**Countries:** CANADA, UNITED STATES, MEXICO **Document ID:** IK1600250  
**Availability:** ISIS, FleetISIS, Body Builder, IsSIR **Revision:** 0  
**Major System:** CAB / SLEEPER / HOOD **Created:** 1/4/2019  
**Current Language:** English **Last Modified:** 5/1/2020  
**Other Languages:** NONE **Author:** Steven Bautz  
**Viewed:** 94

**Title:** Horizon Cab Door Field Replacement and the Side Window Air Deflectors

**Applies To:** MV HV RH LT Lonestar either side front cab door

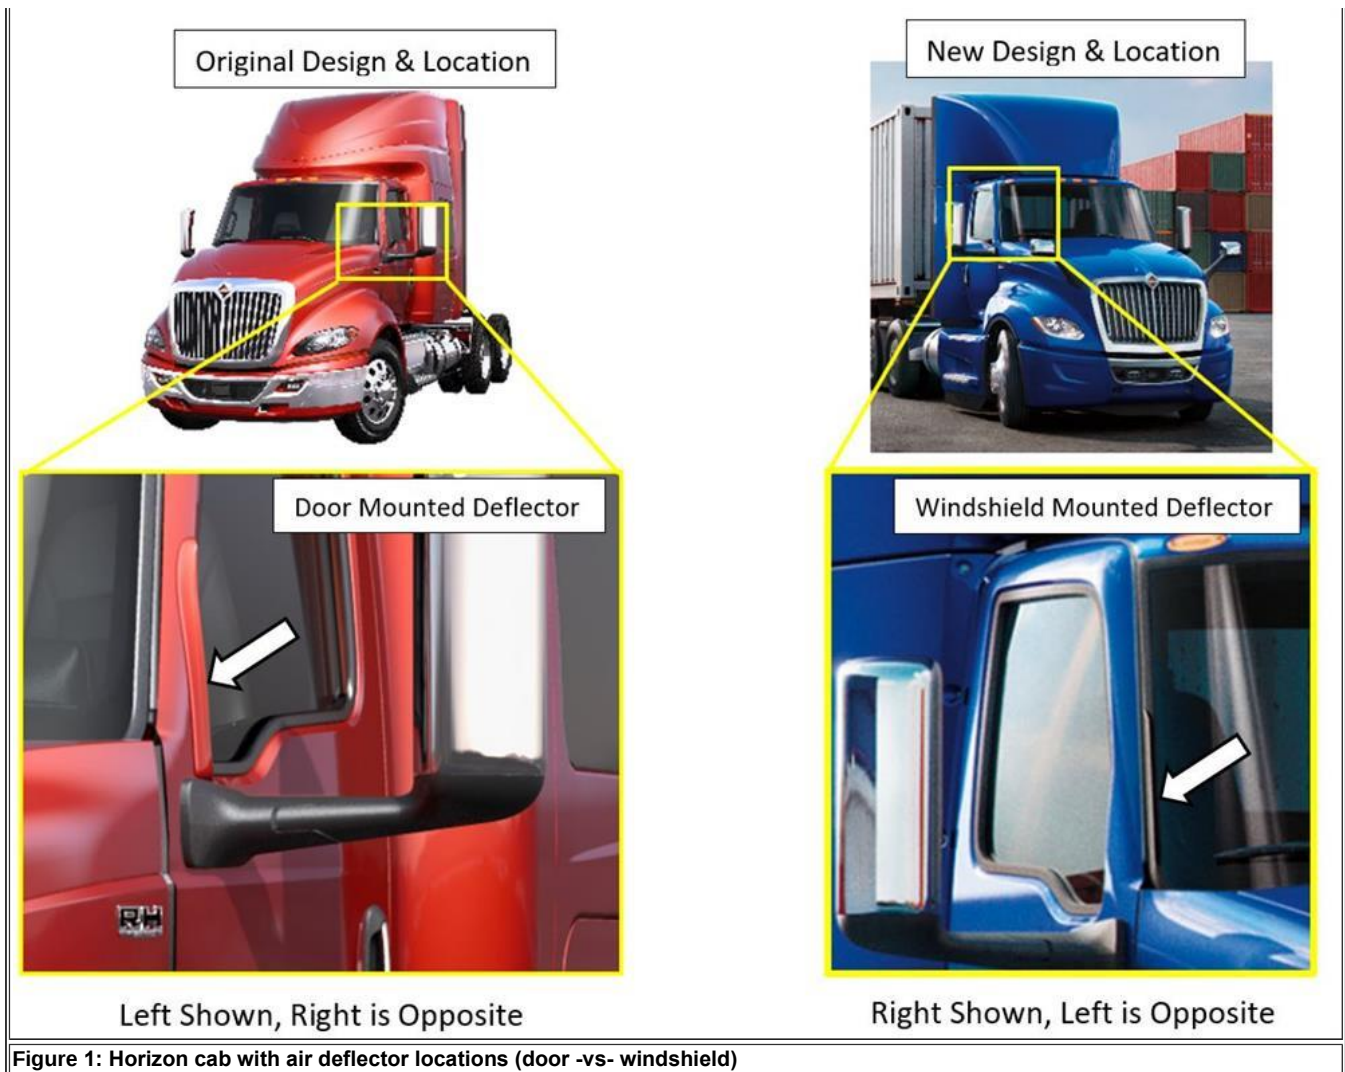
This document will explain the changes being made to the front cab door service parts concerning placement of the side window air deflector. Both driver and passenger side doors that have the side window air deflector currently mounted on the front door pillar will have a different attachment procedure going forward on all service part replacement doors from the PDC. This air deflector design is being changed in production to remove it off of the door pillar and incorporate it onto the windshield seal, both left and right sides of the cab. See figure 1.

Figure 2: Original door panel verses new door panel

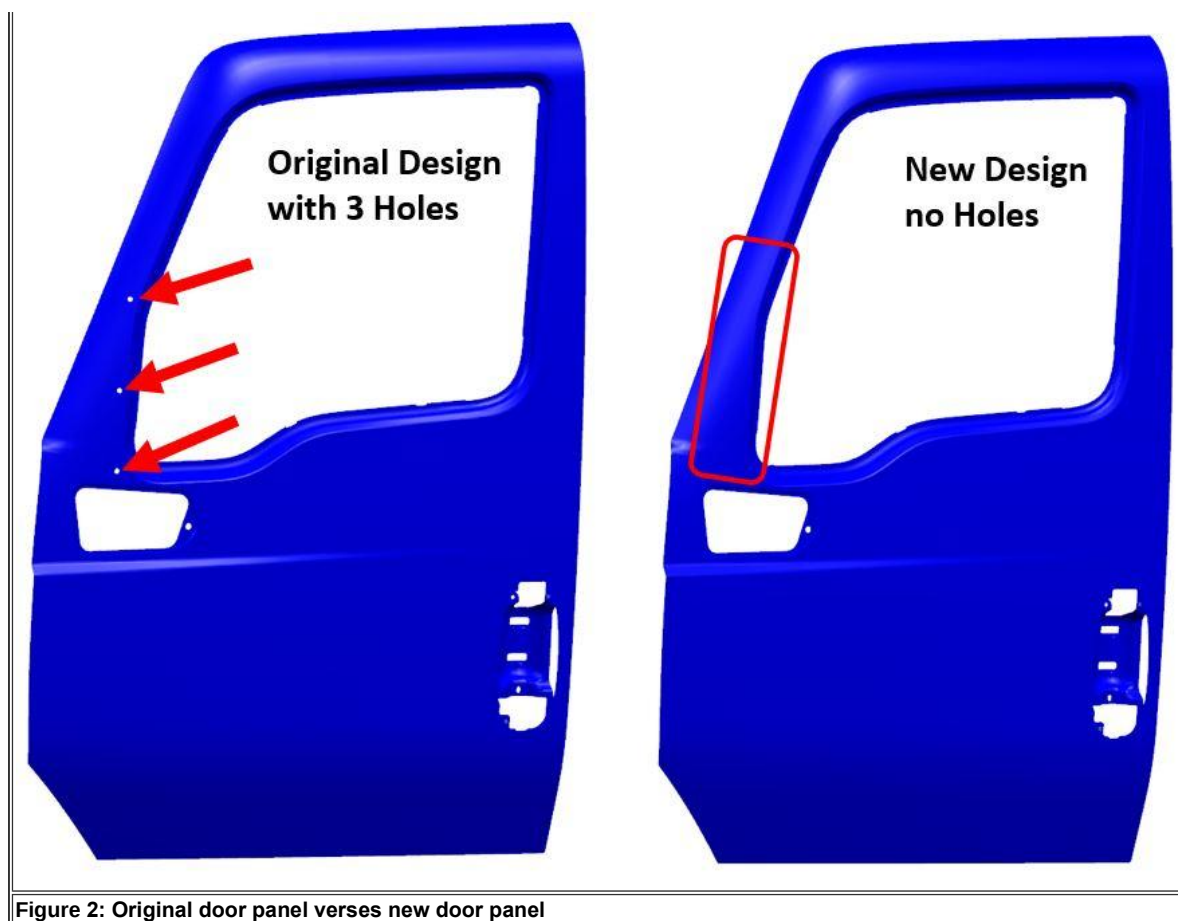
The current deflector is located and attaches to the pillar using three holes that are present in the door pillar. These three holes are being eliminated and the air deflector will have to be modified before it can be attached to the door pillar.

The **NEW** part numbers list will no longer have the 3 holes present for the air deflector.

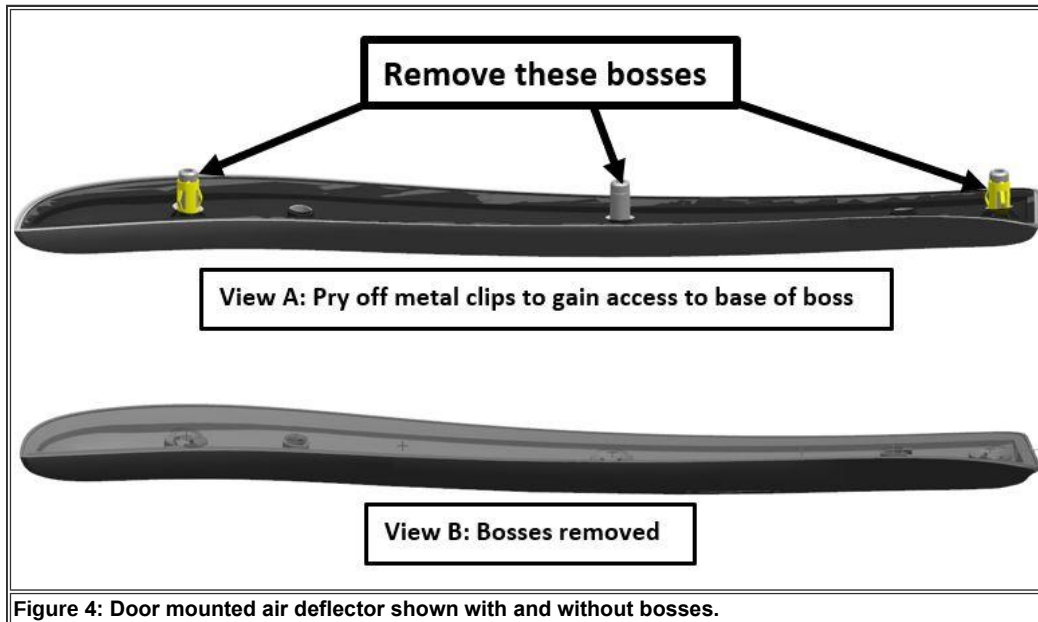
Step 1 - Prior to painting the deflector carefully remove the three mounting bosses on the back side. See figure 4.

Step 2 - Use a side cutter or Dremel rotary tool to cut off the boss. Be careful to NOT damage adhesive.

Step 3 - Sand/grind/drill down the 3 nubs so they are all below the mounting plane of the back side of the deflector.

**Figure 5: Alignment and location of deflector to door panel (left shown, right opposite)**

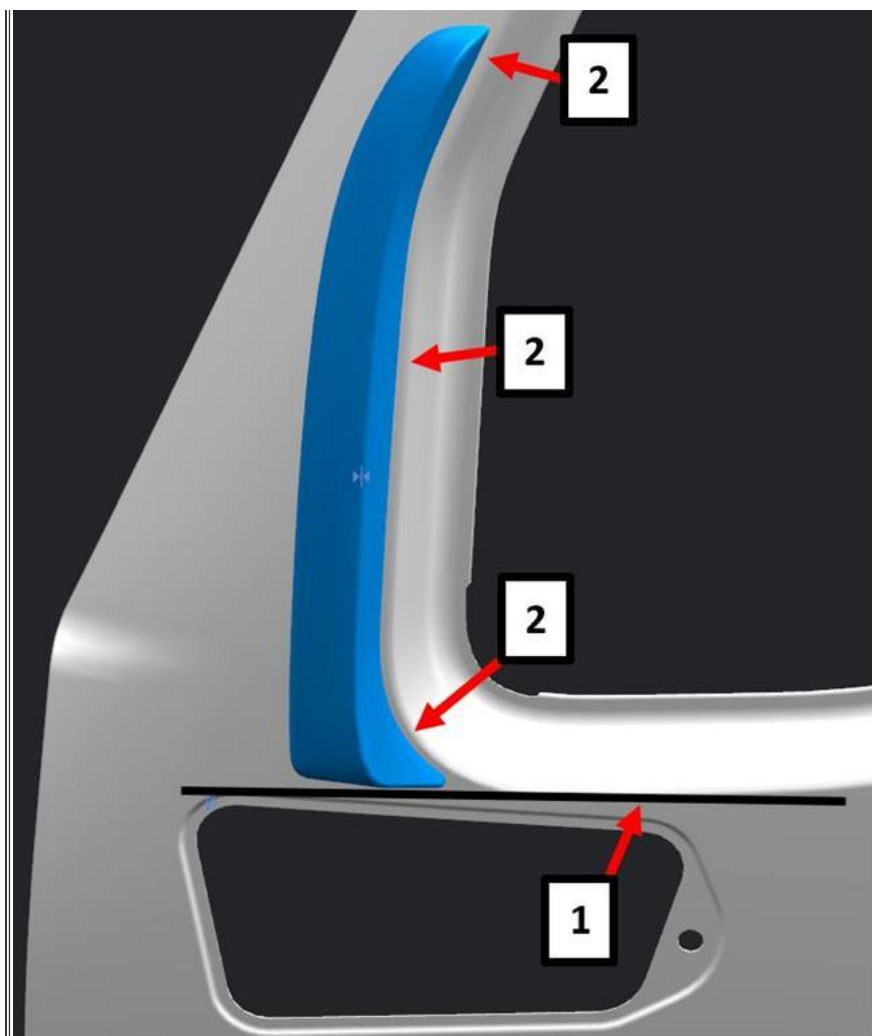
Item 1: Guide line as needed using styling line shown from lower window cutout.  
Item 2: Reference points to match when placing deflector on door.

Step 1 - Mark the door with a dry erase pen or other mark that can be cleaned off without damage to paint. See figure 5, Item 1.

Step 2 - Peel off the preinstalled adhesive liner from the back of the deflector visually align the part with your reference line and the inside edge of the door pillar.
